## Agenda Item # 9

SUB-003588-2025 & SUB-SW-003589-2025

Portside Industrial Park Subdivision, Phase I

- Subdivision approval to create two (2) legal lots of record.
- Waive construction of sidewalks along Rutgers Road and Bowden Road.

# SITE PLAN

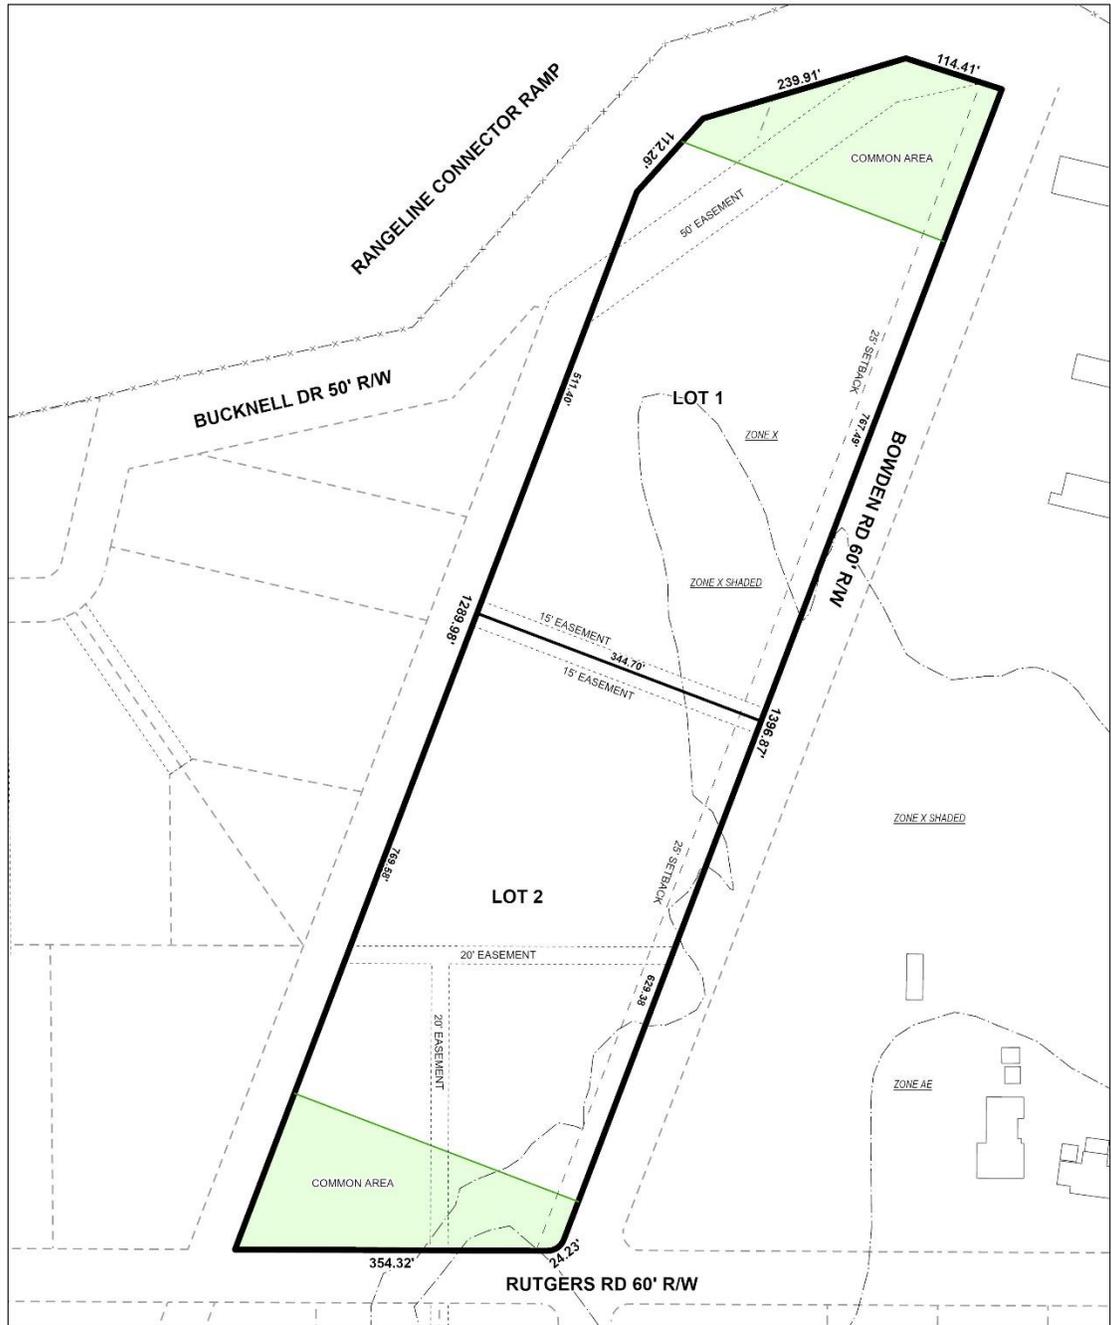
The site fronts onto Bowden Road to the East, Rutgers Road to the South, and Bucknell Drive/Rangeline Road to the North. Bowden Road and Rutgers Road are both minor streets without curb and gutter, but with compliant 60-foot rights-of-way. Therefore, no frontage dedication would be required along either of those roads. If approved, the right-of-way widths of both streets should be retained on the Final Plat. Bucknell Drive is labeled on the preliminary plat with a 50-foot right-of-way but is within the Rangeline Road Major Street Plan right-of-way with a planned 300-foot right-of-way width. Therefore, the right-of-way width of Rangeline Road should be illustrated on the Final Plat, if approved, and if less than 150 feet to the centerline of Rangeline Road, dedication should be required to provide 150 feet from the centerline of Rangeline Road. The site is bounded along the West side by an Alabama Power Company right-of-way of unlabeled width. If approved, the plat should be revised to label the width of this right-of-way.

As proposed, the site has double-frontage lots. As per Section 6.C.7. of the Subdivision Regulations, double frontage lots are discouraged and access shall be limited to one street for the entire block face. Therefore, a waiver of that Section would be required.

The preliminary plat illustrates the 25-foot minimum building setback line along Bowers Road only. If approved, the plat should be revised to also illustrate the 25-foot minimum building setback line along Rutgers Road and Bucknell Drive/Rangeline Road within the Common Areas fronting those streets.

The preliminary plat provides perimeter dimensions for both proposed lots and the Common Areas, and this should be retained on the Final Plat, if approved. However, the proposed lots and Common Areas are not labeled with their sizes. Therefore, if approved, the plat should be revised to label both lots and Common Areas with their sizes in both square feet and acres, or a table should be furnished on the Final Plat providing the same information.

As the site is proposed to have Common Areas, a note should be required on the Final Plat, if approved, stating that the maintenance of all Common Areas is the responsibility of the property owners.

The preliminary plat indicates various easements within the proposed subdivision. Therefore, if approved, a note should be placed on the Final Plat stating that no structure shall be constructed or placed in any easement without permission of the easement holder. Furthermore, as the site is bordered along the West side by an Alabama Power Company right-of-way, a note should be required on the Final Plat stating that access to this right-of-way is denied.

1. Retention of the right-of-way widths of Bowden Road and Rutgers Road on the Final Plat;
2. Labeling of the right-of-way width of Rangeline Road on the Final Plat, and if less than 150 feet to the centerline of Rangeline Road, dedication to provide 150 feet from the centerline of Rangeline Road;

3. Revision of the plat to label the width of the Alabama Power Company right-of-way along the West boundary of the site;
4. Retention of the 25-foot minimum building setback line along Bowers Road on the Final Plat;

5. Revision of the plat to also illustrate the 25-foot minimum building setback line along Rutgers Road and Bucknell Drive/Rangeline Road within the Common Areas fronting those streets;

6. Retention of the perimeter dimensions for both proposed lots and the Common Areas on the Final Plat;
7. Revision of the plat to label both lots and Common Areas with their sizes in both square feet and acres, or the furnishing of a table on the Final Plat providing the same information;

8. Placement of a note on the Final Plat stating that the maintenance of all Common Areas is the responsibility of the property owners;
9. Placement of a note on the Final Plat stating that no structure shall be constructed or placed in any easement without permission of the easement holder;

10. Placement of a note on the Final Plat stating that access to the Alabama Power Company right-of-way along the West boundary is denied;
11. Compliance with all Engineering comments noted in this staff report;
